Type II Staff Report and Decision

Project Name:	**BURBACK CLUSTER SHORT PLAT**
Case Number:	**PLD2015-00024; EVR2015-00027; GEO2015-00014**
Location:	**14810 NW Seward Road**
Request:	**The applicant is request Cluster Short Plat approval to divide 15 acres into 3 single-family residential lots and one remainder lot located in the R-5 zone district.**
Applicant:	**Burback Family, LLC** **1405 SE 75th Court** **Vancouver, WA 98664** **(503)313-0791** **larryburback@gmail.com**
Contact Person:	**PLS Engineering** **Travis Johnson** **2008 C Street** **Vancouver, WA 98663** **(360)944-6519; (360)944-6539 fax** **travis@plsengineering.com**
Property Owner:	**Same as applicant**

Approved, subject to Conditions

Development Plan For:
Burback CSP
A Site Located in Clark County

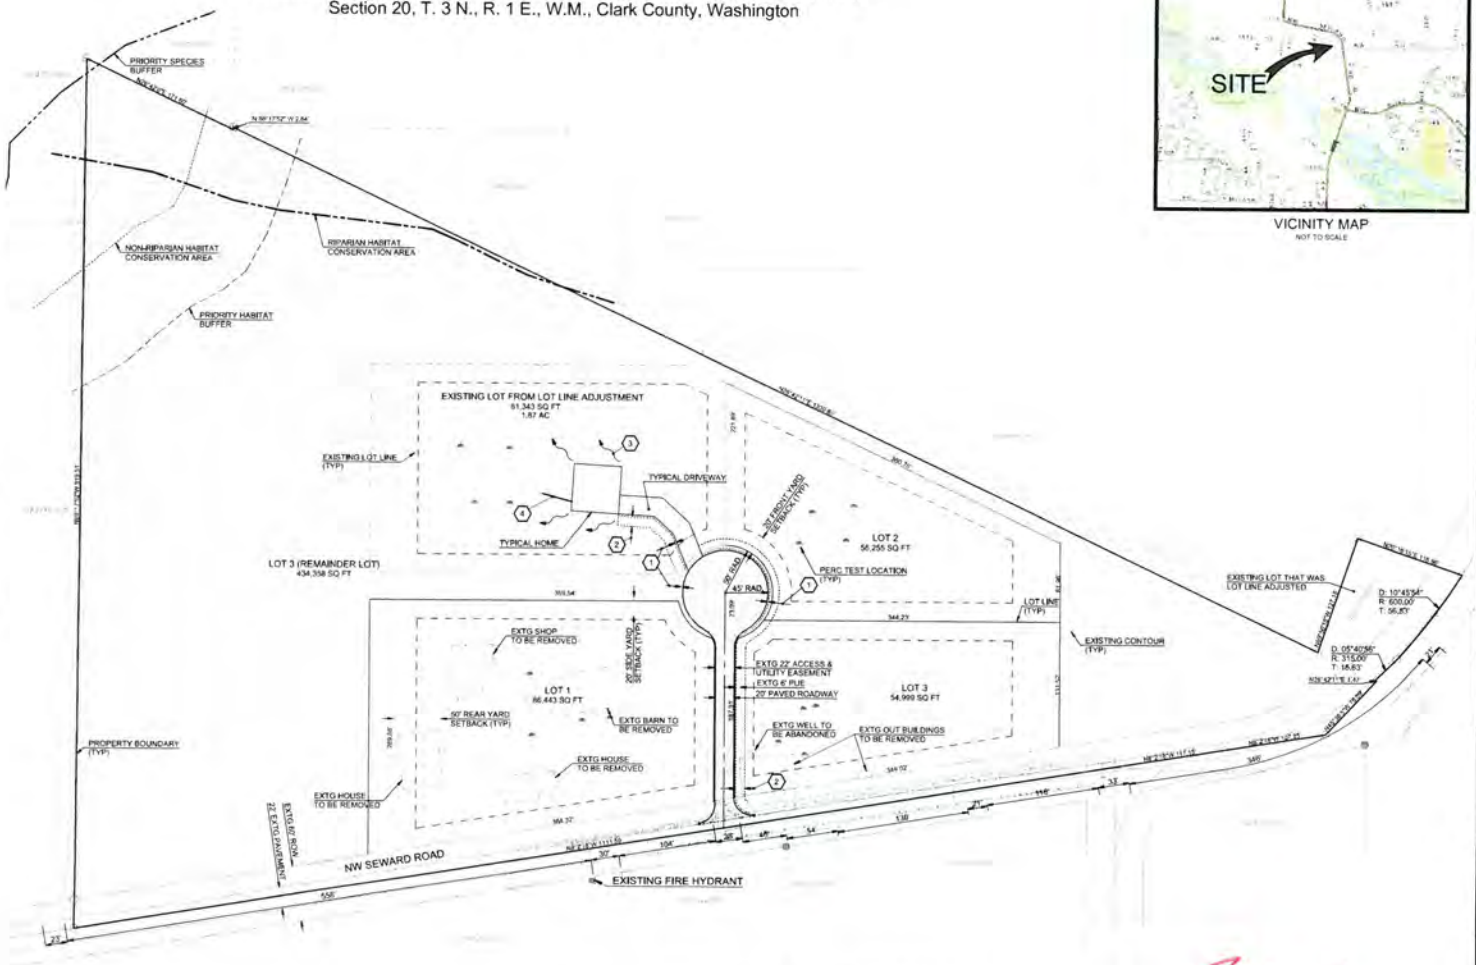
The remainder lot is shown as Lot 3 on the preliminary plat. A cluster lot has the same number. The lots shall be renumbered to avoid having duplicate numbers. See Condition D-5.

The preliminary plat identifies building envelopes that correctly show the 20-foot setback lines. Twenty foot setbacks are also shown on the preliminary plat for the adjusted lot; however, since this is not a cluster lot, it does not qualify for a 20 foot front setback, and should be designated as "not a part of this plat." See condition D-6.

40.210.020.D.6.a requires the use of native landscape materials to provide 50% opacity screening of cluster lots. The landscape plan proposes Leyland Cypress (a non-native) along the east property line of Lot 3 with no shrubs.

A revised landscape plan is required using native plants; native shrubs shall also be required on the plan.

The development will be visible from the north part of the remainder lot as well, so additional landscaping needs to extend along Seward road to the northwest tip of the site. Existing trees can be used as part of the screening requirements. Any existing trees to be retained shall be identified on the landscape plan.

The sight distance letter notes that between 4 and 8 of the existing cedars that currently provide screening along Seward Road will need to be removed. The landscape plan shall show which trees will be removed. If other existing trees are to be used for screening in their stead, they must be shown on the landscape plan. See conditions A-7.a, A-7.b and D-10.

a. The landscape plan shall meet the requirements in CCC40.210.220.D.6.
b. Existing landscaping used to fulfill screening requirements shall be shown on the landscape plan. (See Land Use Finding 5)

D-5 The lots shall be renumbered to avoid having duplicate numbers. See Land Use Finding 2.

D-6 Taxlot 986036-584 shall be labeled "not a part of this plat". See Land Use Finding 3.
